Planning Commission Staff Report

July 8, 2015
Item 5.a

- SUBJECT:** PUD-68-06M
- APPLICANT:** Stoneridge Creek Pleasanton CCRC
- PROPERTY OWNER:** Stoneridge Creek Pleasanton CCRC
- PURPOSE:** Application for a Major Modification to an approved Planned Unit Development (PUD-68) development plan to reduce the unit count, modify the density, construct subterranean parking, amenities, and related site improvements in the northern 10 acres of the Continuing Life Communities retirement community.

Figure 3: Original and Proposed Partial Site Plans

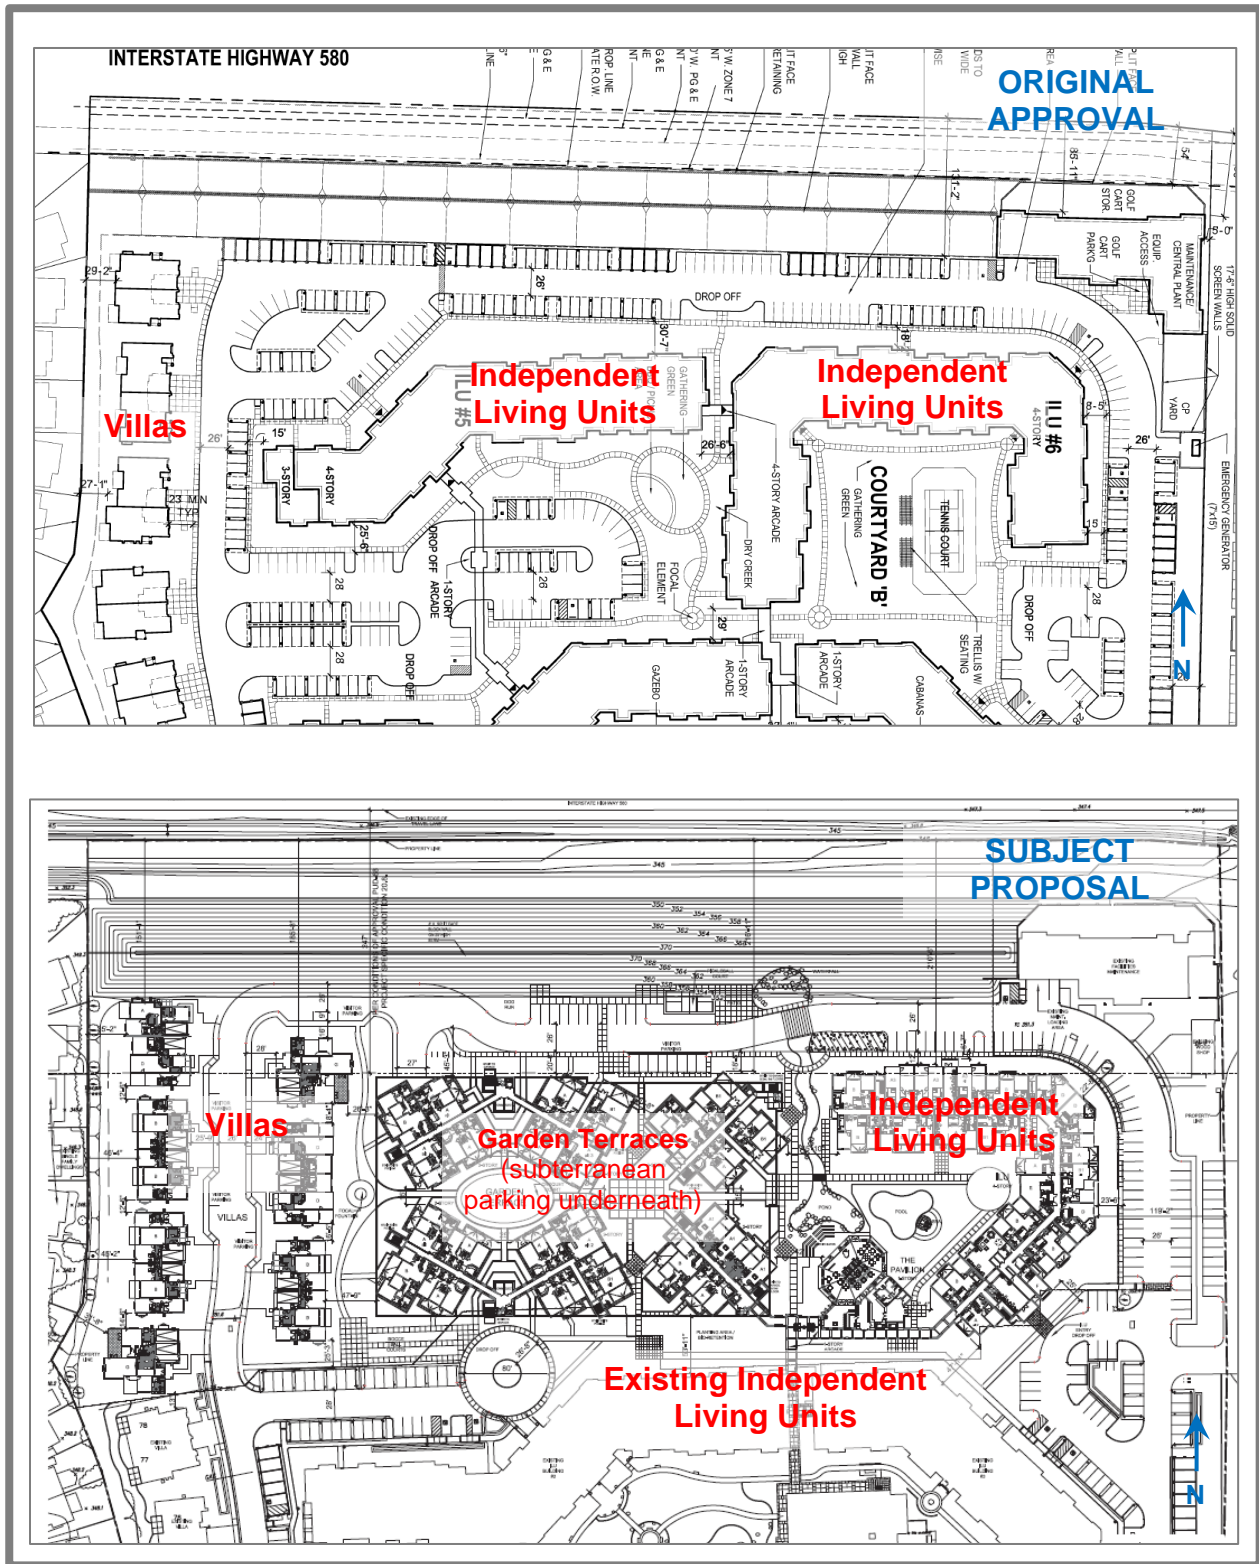
- **Proposed Units:** The total number of units is currently 414 since 10 units were combined to make 5 penthouse units. As indicated in Figure 3, two ILU buildings containing a total of 208 units were approved in the northern portion of the subject site (identified as ILU #5 and ILU #6 on the site plan for the original approval), along with a total of 8 Villas.

- **Project Access/Site Plan:** Access to the site will remain as existing, via Stoneridge Creek way from Stoneridge Drive. Streamside Circle provides a "loop" access around the existing buildings, and would be adjusted to provide a "loop" access around the proposed north phase. Villa units are proposed on both sides of Streamside Circle, where with the original approval they were located only on the western side of the street. The Villa units were setback between about 27 feet to 29 feet from the western property line on the original approval whereas the subject plans show setbacks varying from 31-feet-8-inches to 46-feet-4-inches.
